**PCN for SMD kHz crystal, FC-255 taping and shipping spec**

1. Affected Products : SMD type kHz Crystal unit
  - FC-255:Product code Q14FC255000\*\*/Q13FC255000\*\*

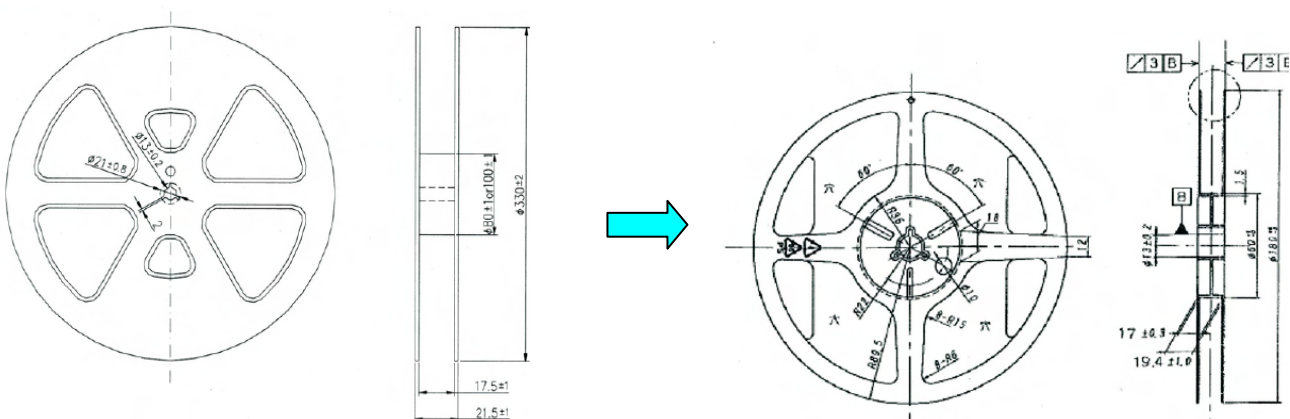
- (1) Crystal unit loading pitch of taping will be changed from 8mm to 4mm.

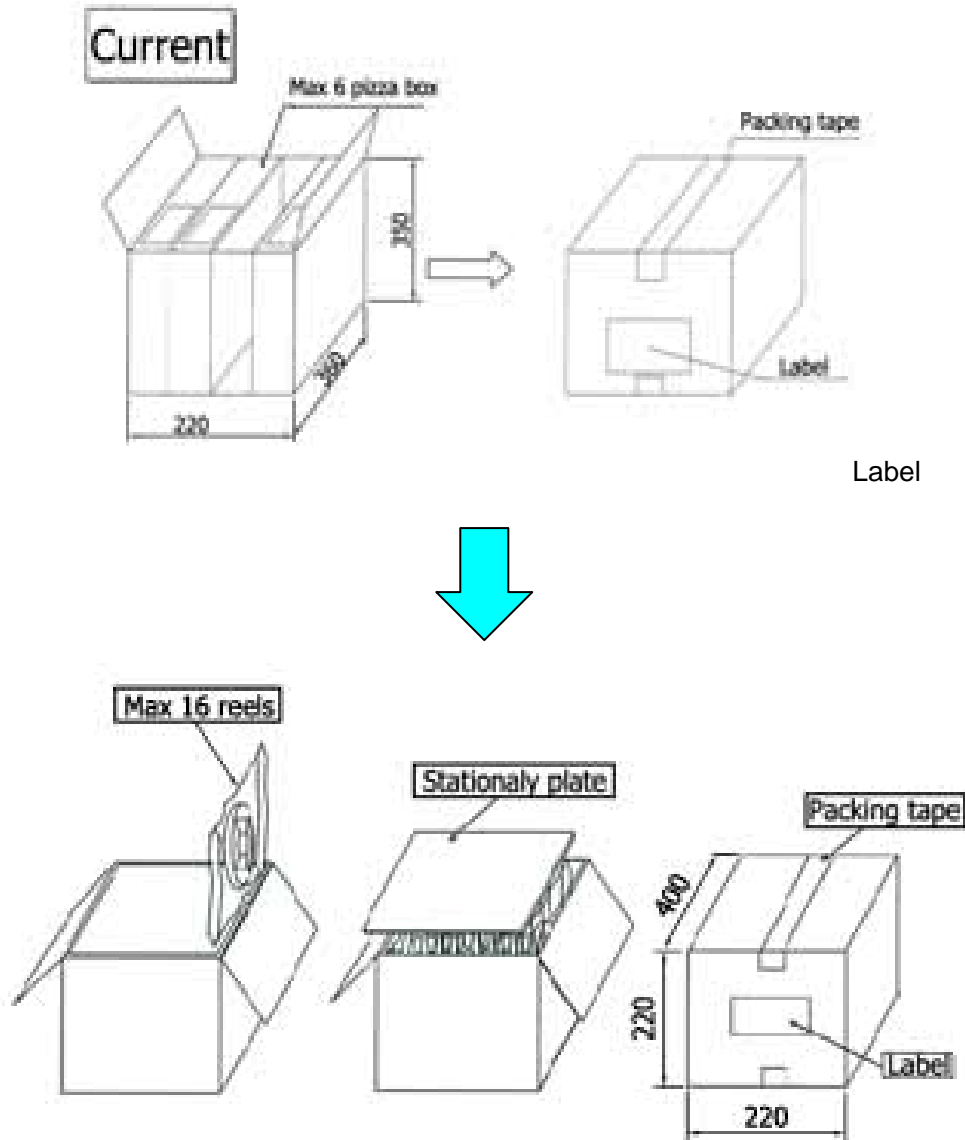
- (2) Reel diameter changed from φ330mm to φ180mm.

Reel diameter φ330mm

Reel diameter φ180mm
